July 25, 2006
File: 84438704, 84400042

Reference: Clover Valley DEIR
Response to Letter of June 21, 2006

From: Gonzalez, Davina
Sent: Wednesday, August 09, 2006 7:27 AM
To: Doug Moore (dmoore@westyost.com)
Cc: O'Hagan, Michael
Subject: Clover Valley Lakes Hydrology/Hydraulics

SUBJECT: Clover Valley Project No.: 279-00-05-04.06

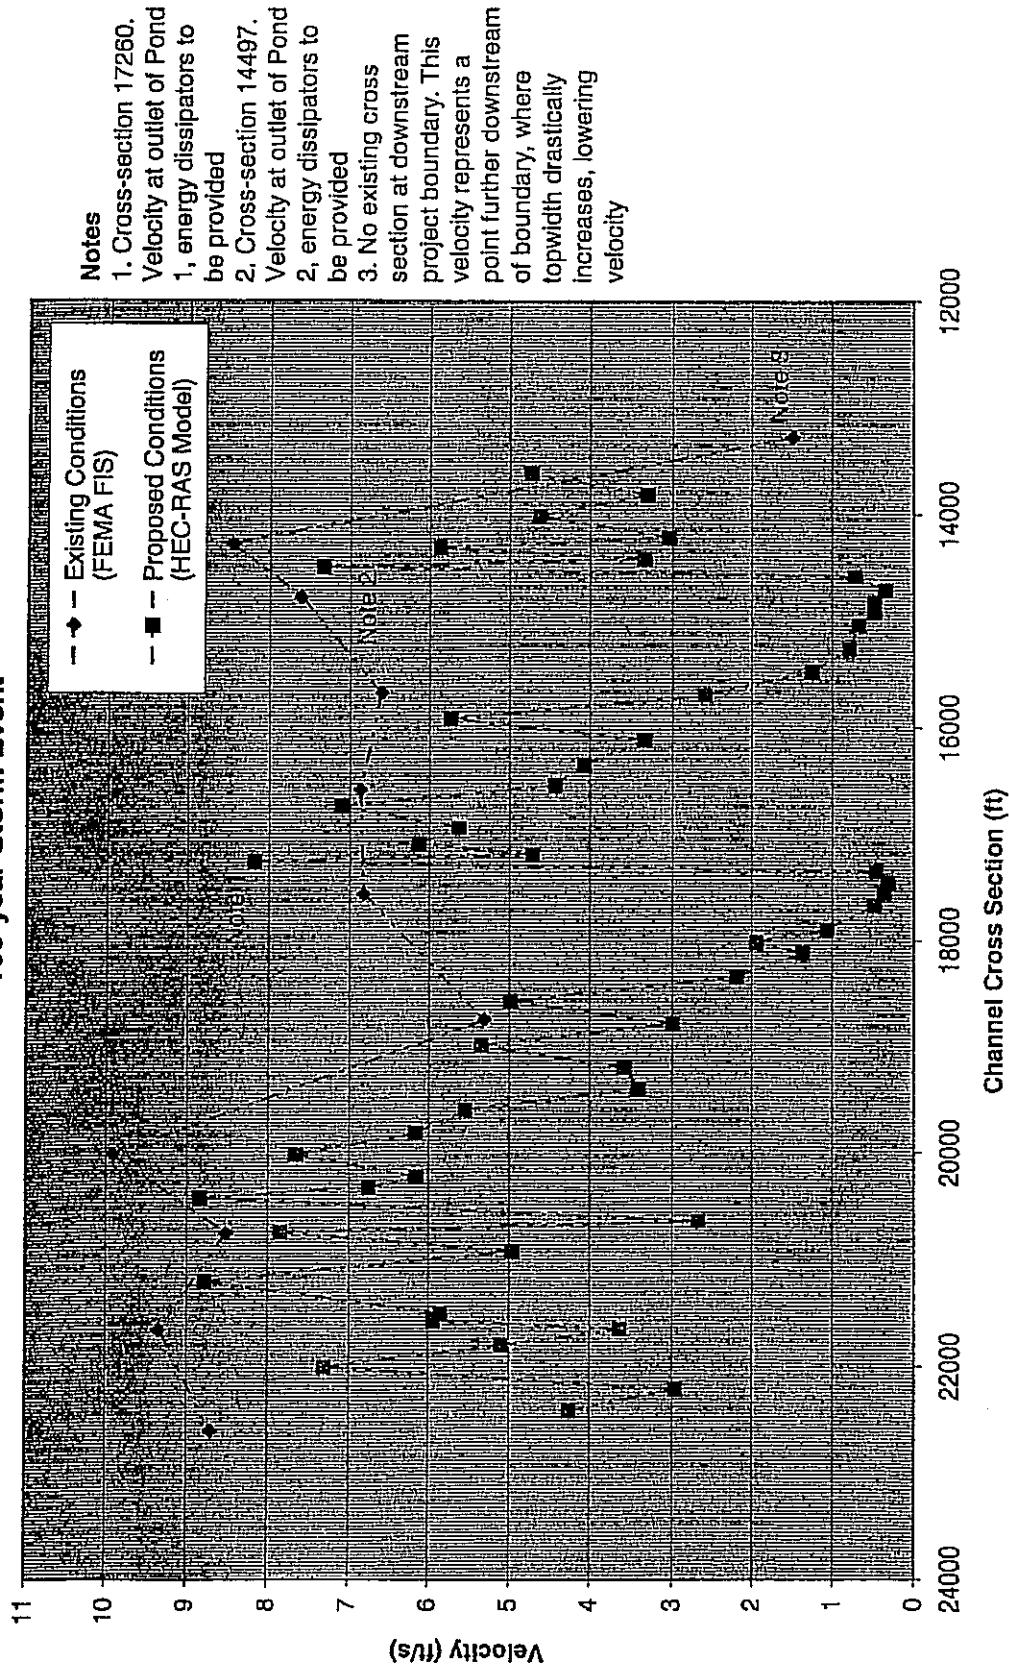
5) On the figure showing the existing and proposed flood plains, the proposed plain just downstream of pond 1 is smaller than the existing plain. Please explain why. The proposed flood plain is more confined due to the use of culverts . The existing flood plain is quite wide and not restrained; the placement of the roadway will restrict the flow in the overbank area to the easterly side with flows being "forced" through the culverts located more on the westerly side of the creek area.

Clover Valley Creek Velocity Profile 100-year Storm Event

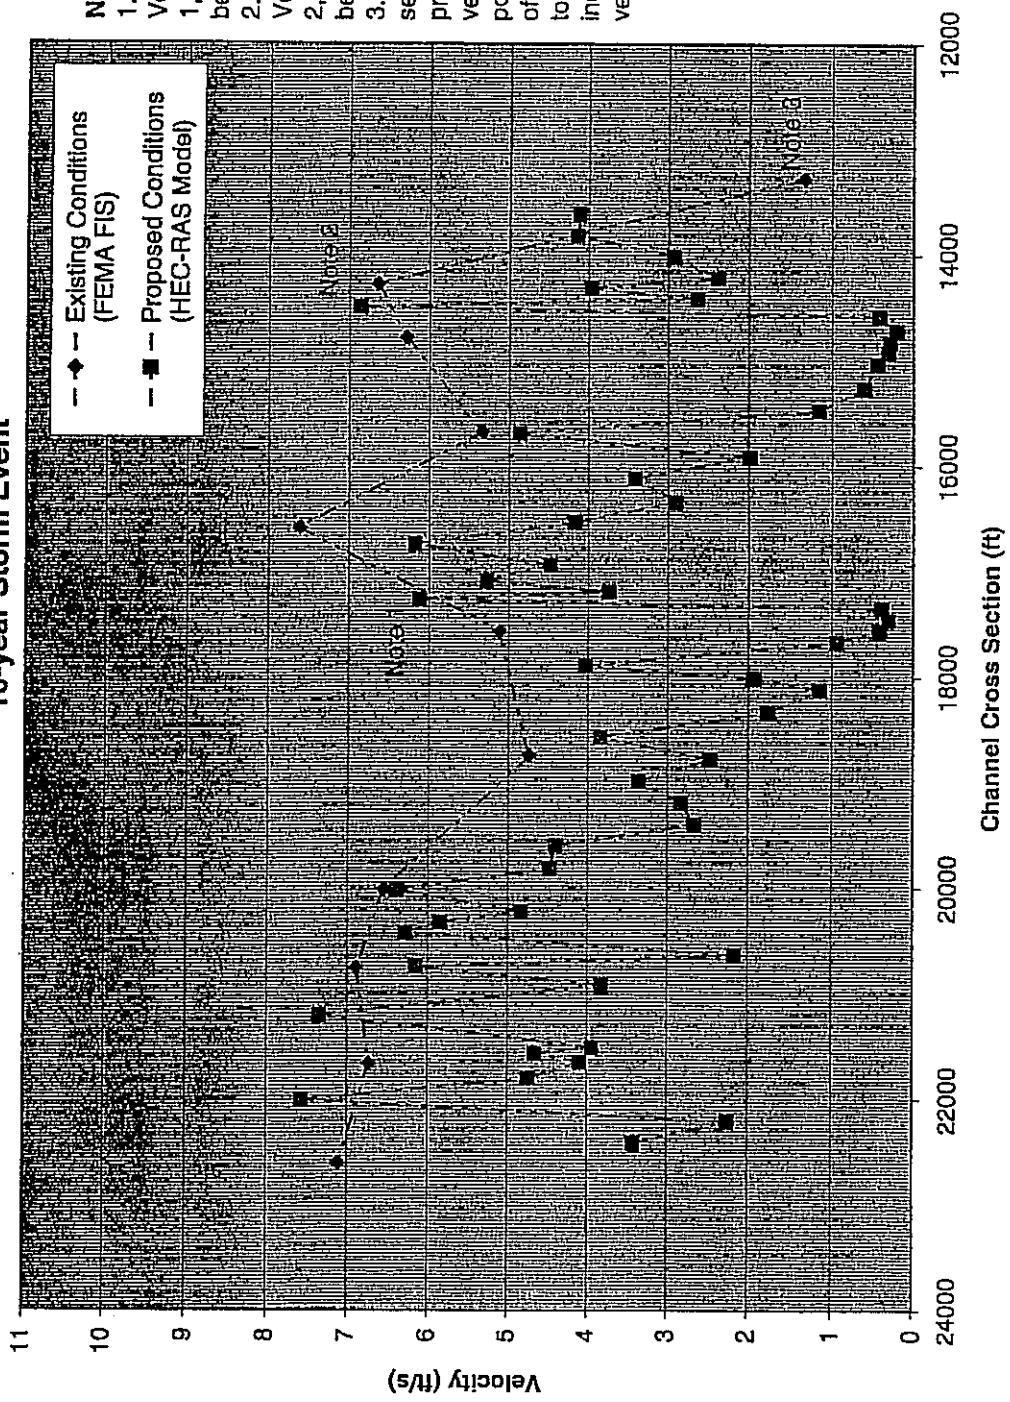
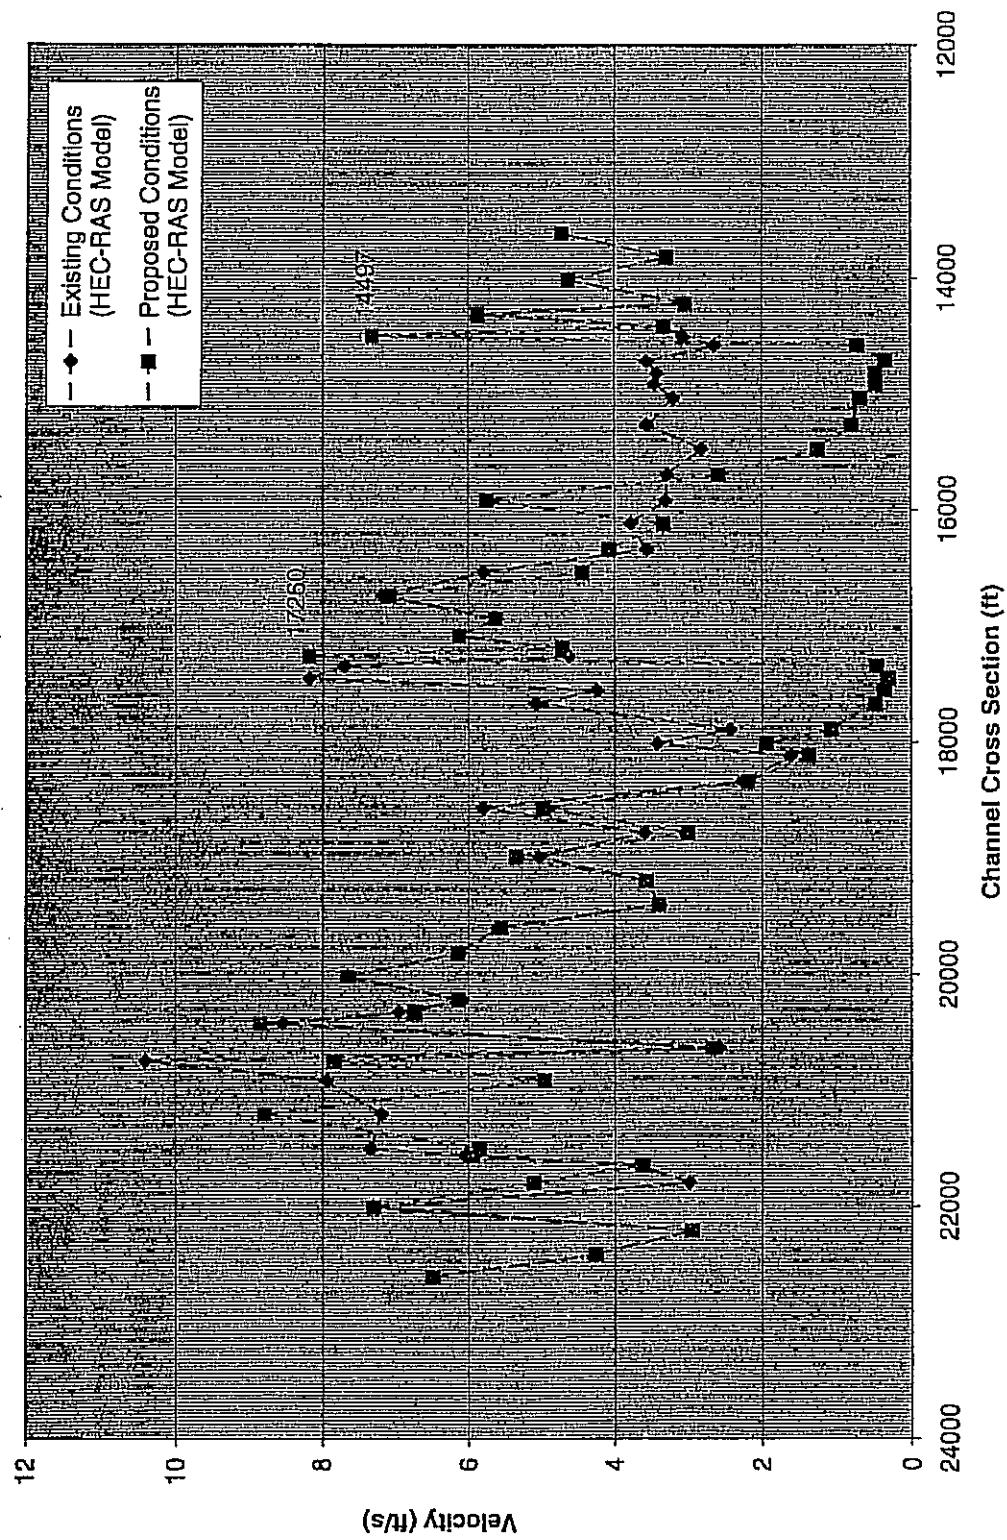
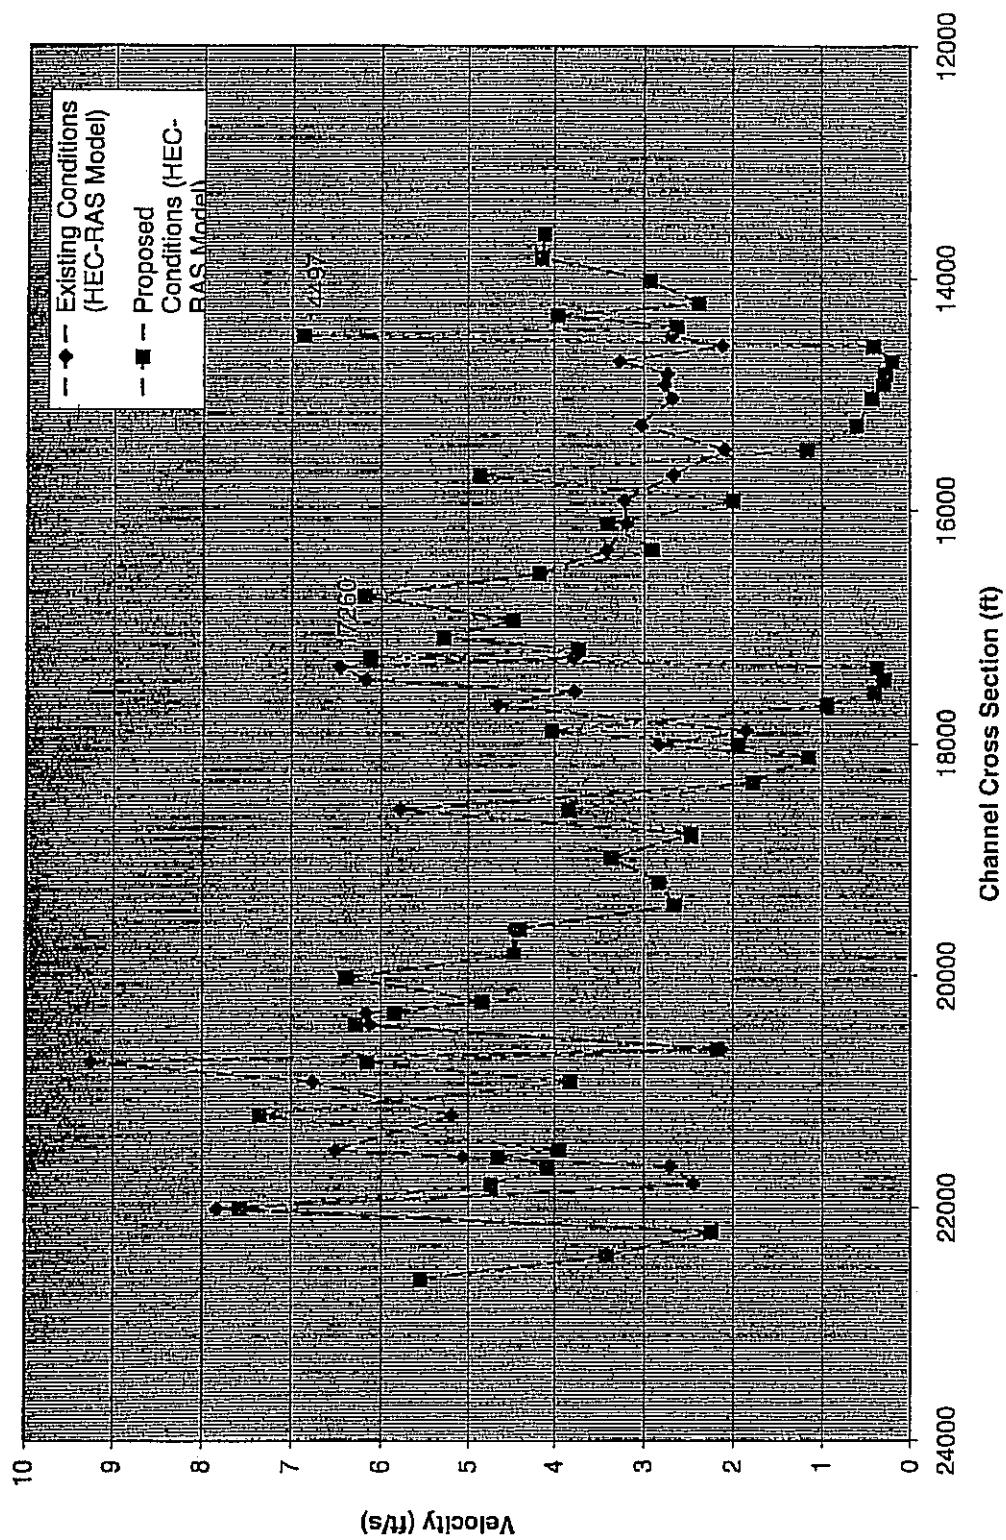
2) The velocity profile has omitted many data points (versus what is provided in the CLOMR application). For example, downstream of pond 2, your profile shows only a peak velocity of 4.4 feet per second. The CLOMR data indicates that at station 17,260 (just downstream of the pond), the 100-year velocity is 9.4 feet per second. A velocity of 9.4 feet per second will cause scour of the channel, which may undermine the roadway crossing. Please revise the velocity profile and include all the data points. Please provide velocity profiles for the 10-year and 2-year storms (if available). Please address how this scour problem will be resolved, particularly since the soils are silty sands. Thank you for your input. I have generated new velocity profiles to include all velocity points. One area of discrepancy is with velocities from the FEMA model (HEC-2) compared to velocities from the HEC-RAS model (utilizing HEC-1 generated proposed-condition flows). The FEMA model uses a peak flow of 740 cfs, higher than the HEC-1 existing flow of 610 cfs. Also, the FEMA model does not place a cross section at the project's downstream boundary, thus the existing vs. proposed condition velocities are not a direct comparison at the downstream boundary. On the other hand, the HEC-RAS velocities are modeled with proposed condition flows only. This may be the closer comparison given the fact that the existing and proposed flows at the ponds differ by approximately 5%. I have included both scenarios, and recommend drawing a comparison from the HEC-RAS velocities. Velocity profiles attached.

With regards to a velocity of 7-8 ft/s at the road crossings, velocity dissipators will be placed downstream of the road crossings to reduce scour. An energy dissipator device will be chosen at a later time that reduces scour and minimizes to the maximum extent practicable the impacts of a rough channel bottom on the creek habitat.
